ADDENDUM NO. 3

PORTER TOWNSHIP ADMINISTRATION BUILDING
Valparaiso, IN 46341

ADDENDUM THREE

Addendum Three (AD.03) to the drawings and specifications prepared by Gibraltar Design for **Porter Township Administration Building** for Porter Township School Corporation, Valparaiso, Indiana.

© GIBRALTAR DESIGN
SHEET
A-620

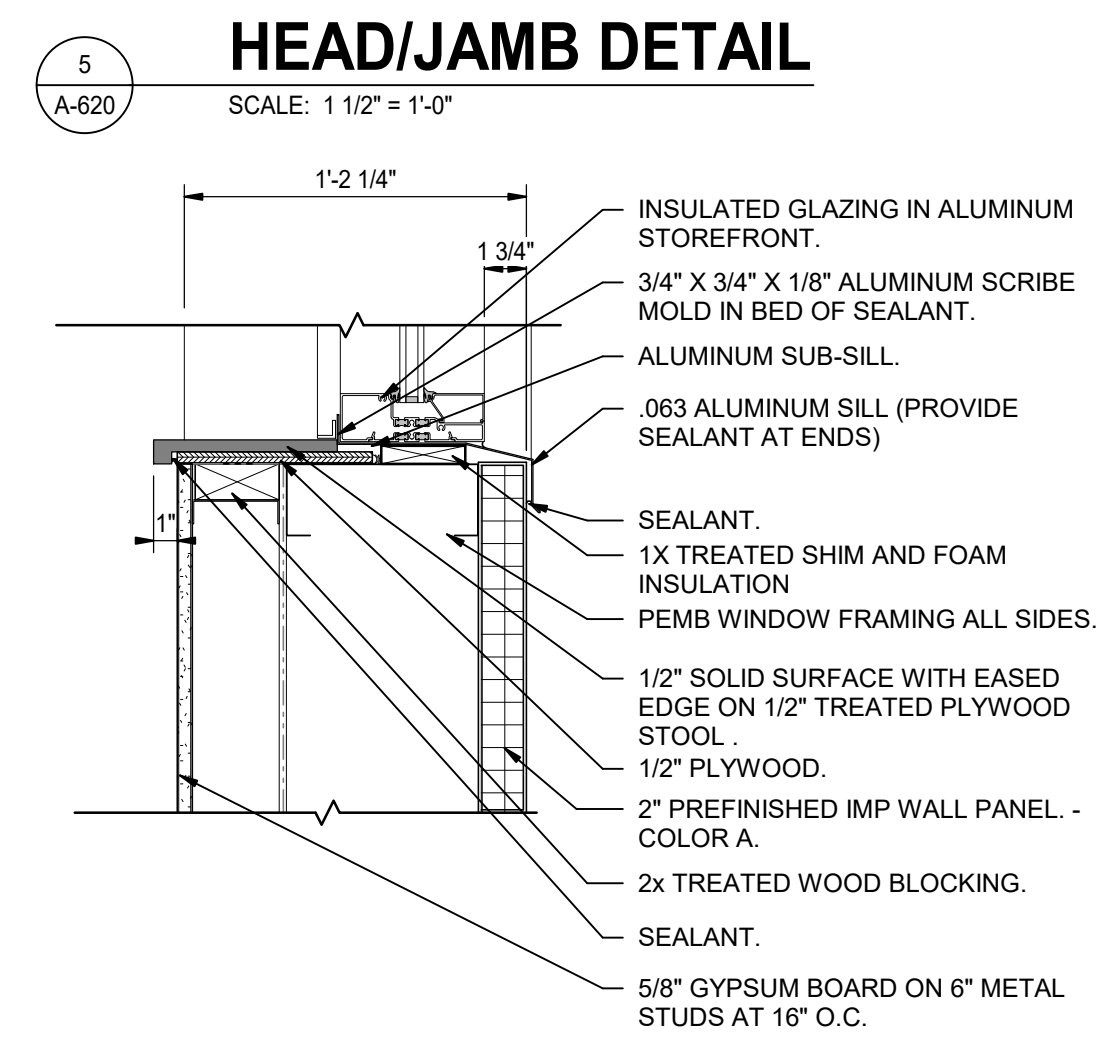
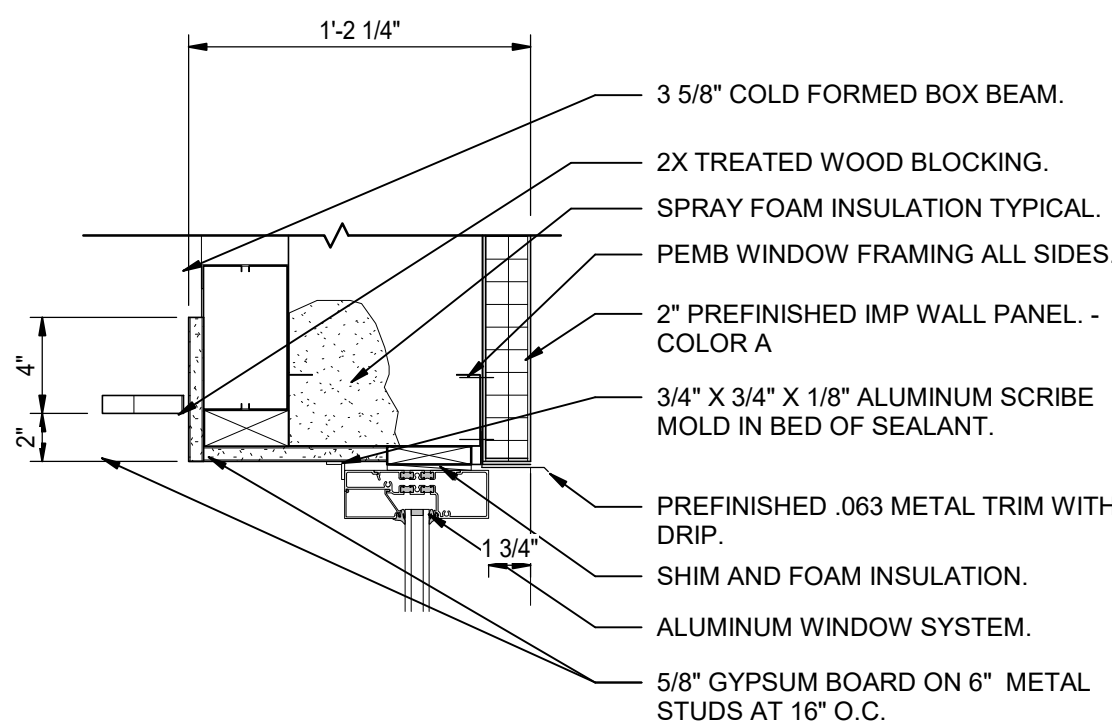
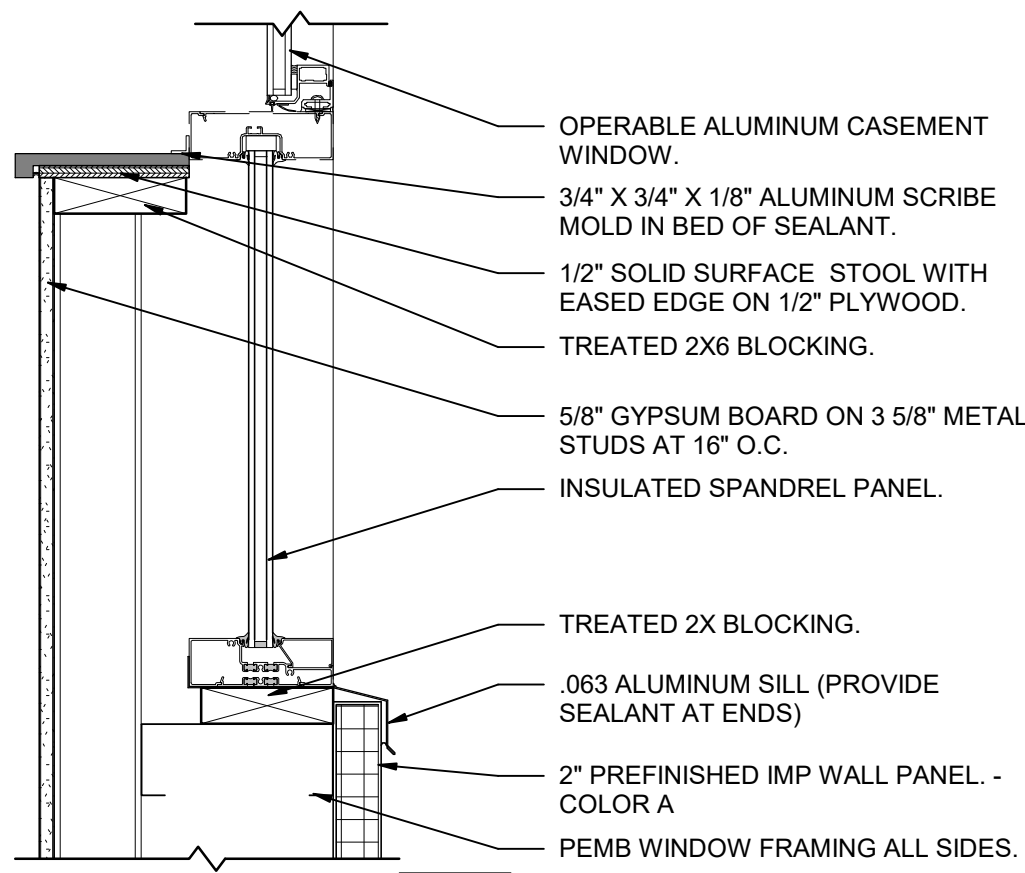
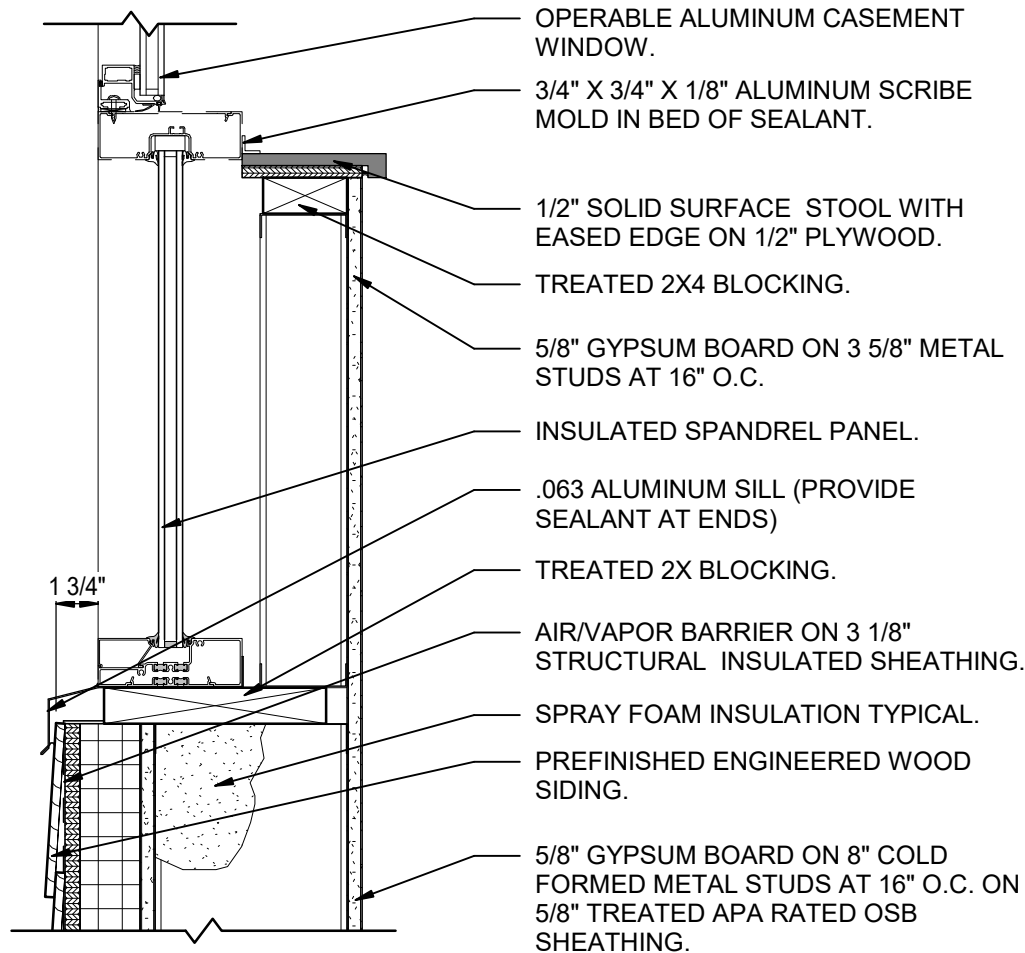
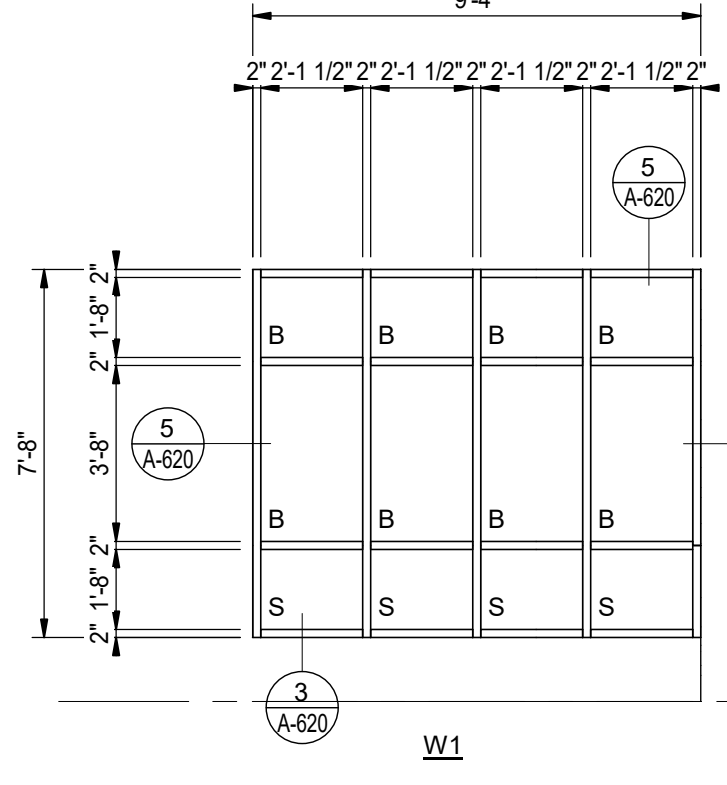
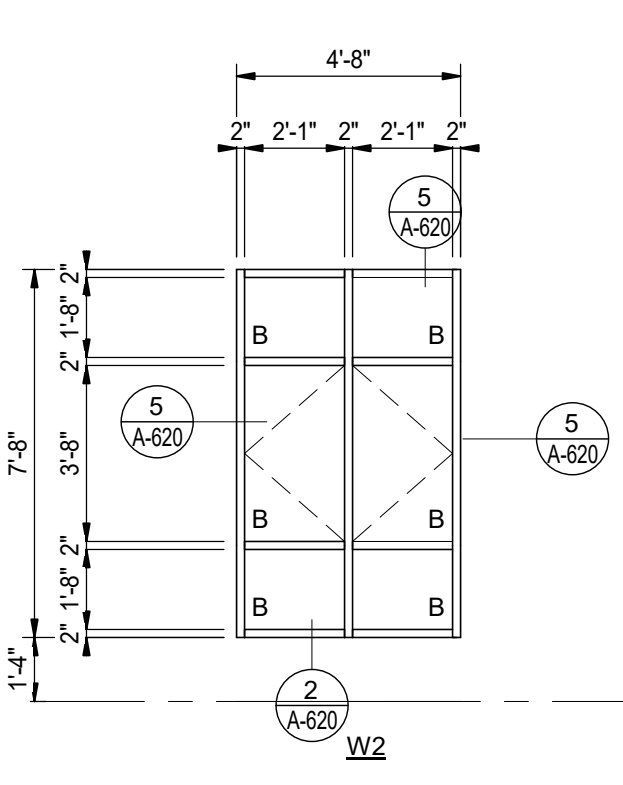
11. Sheet A-620

- A. Refer to revised, full-size drawing, included in this Addendum, for revisions.
 1. Revised W3 window elevation.

ELECTRICAL LIGHTING FIRST FLOOR CEILING PLAN - SCOPE B
1 EL101 1/8" = 1'-0"

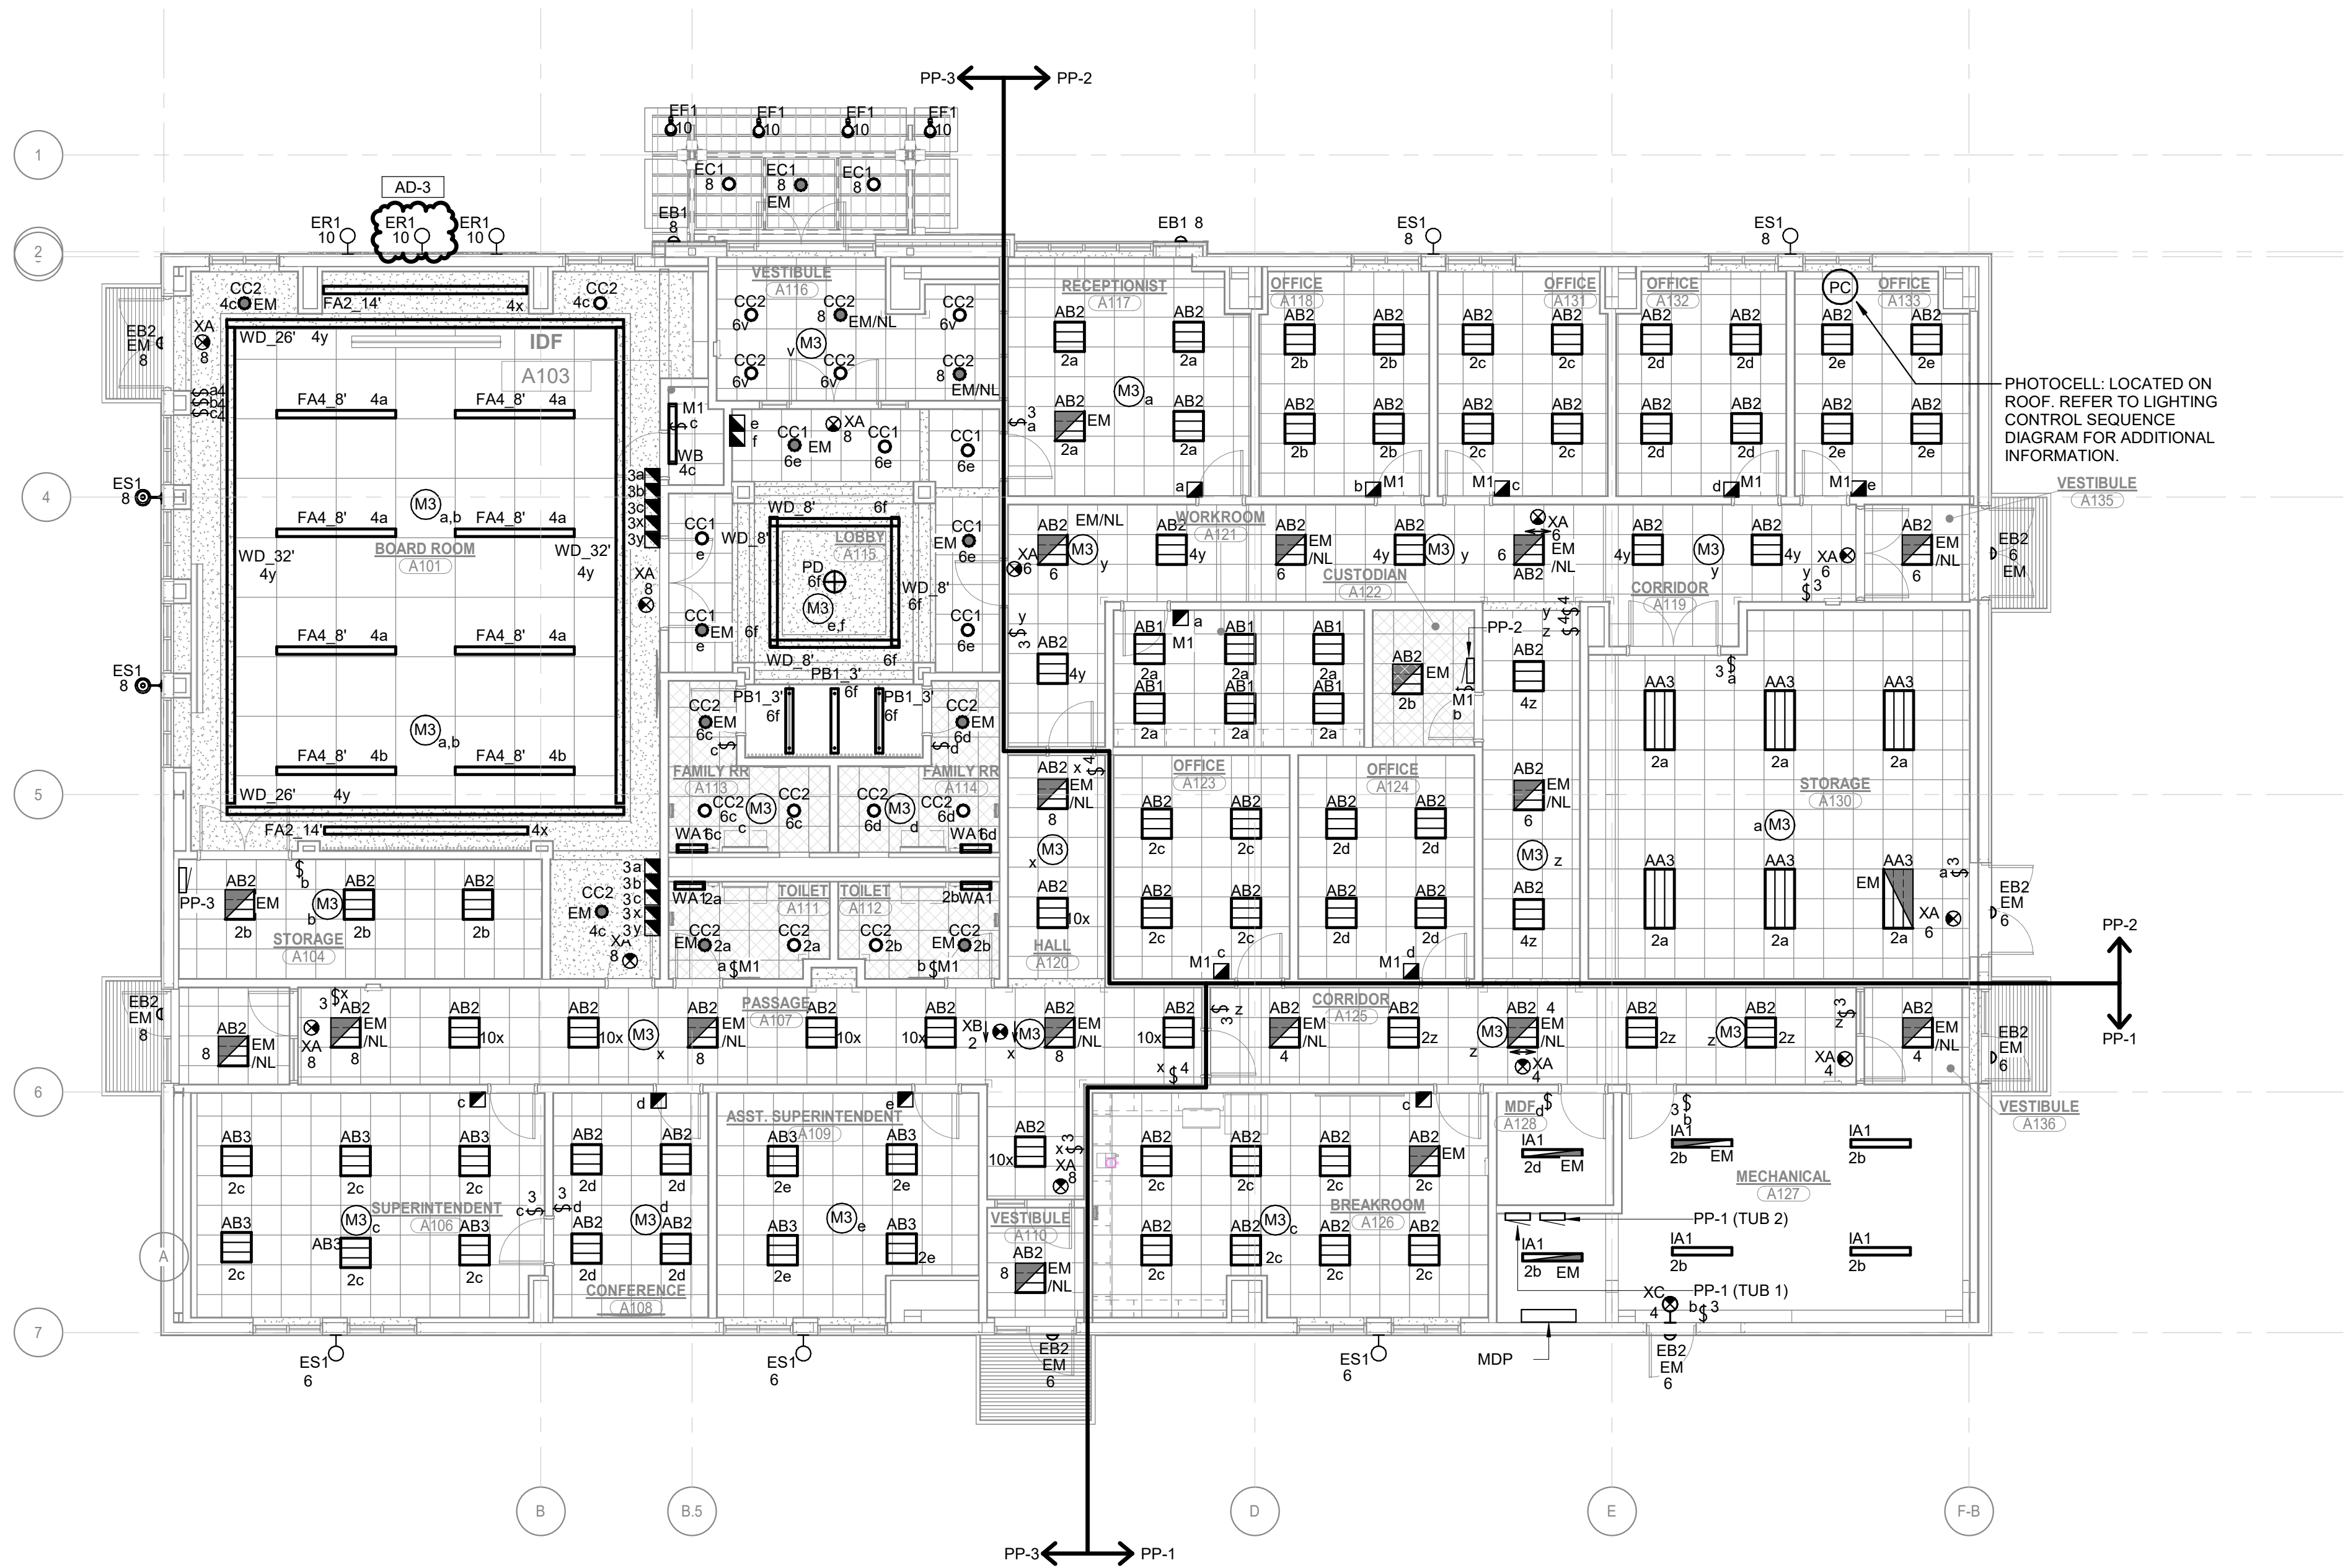
13. Sheet EL101

- A. Refer to revised, full-size drawing, included in this Addendum, for revisions.
 1. Added fixture ER1.
 2. Revised ER1 fixture locations.

E-602

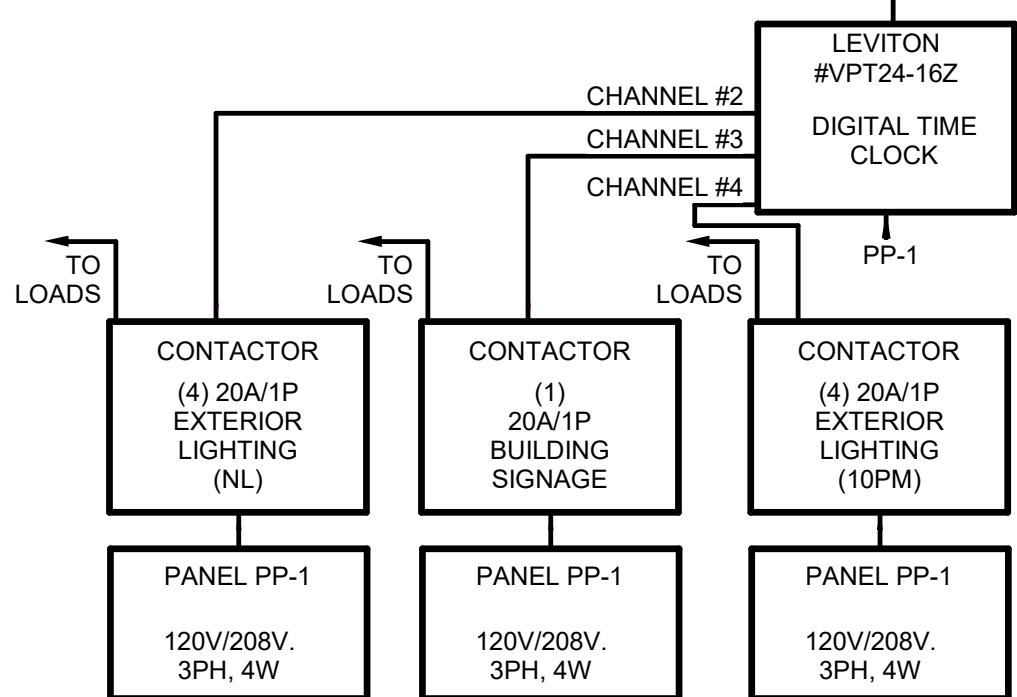
14. Sheet E602

- A. Refer to revised, full-size drawing, included in this Addendum, for revisions.
 1. Revised EF1, PB1_3', and ER1 fixture specifications.
